PCM 09 Calibration Update—Optional

NOTICE

Revised December 2015. This bulletin supersedes the previous bulletin number 2015-01 February 2015.

Caution

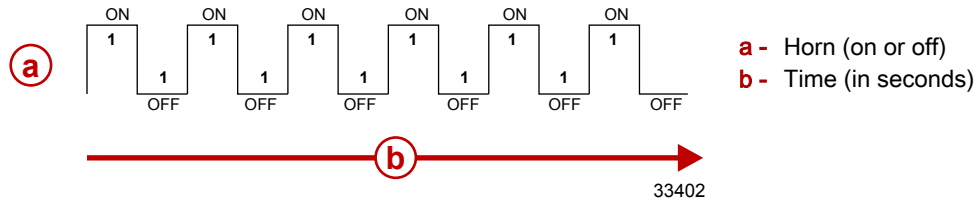
If a caution state is detected, the audio warning system will sound for six one-second intervals.

Nonconfigured Alarm—DTS Only

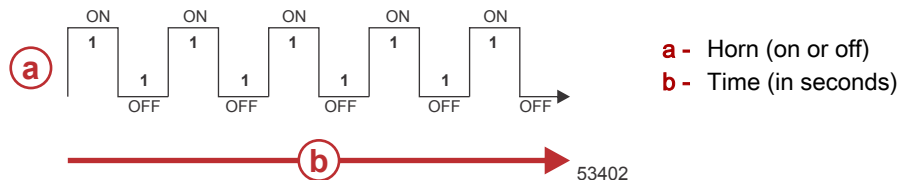
If the helm has not been properly configured using the G3 service tool, the audio warning system will sound for five one-second intervals.
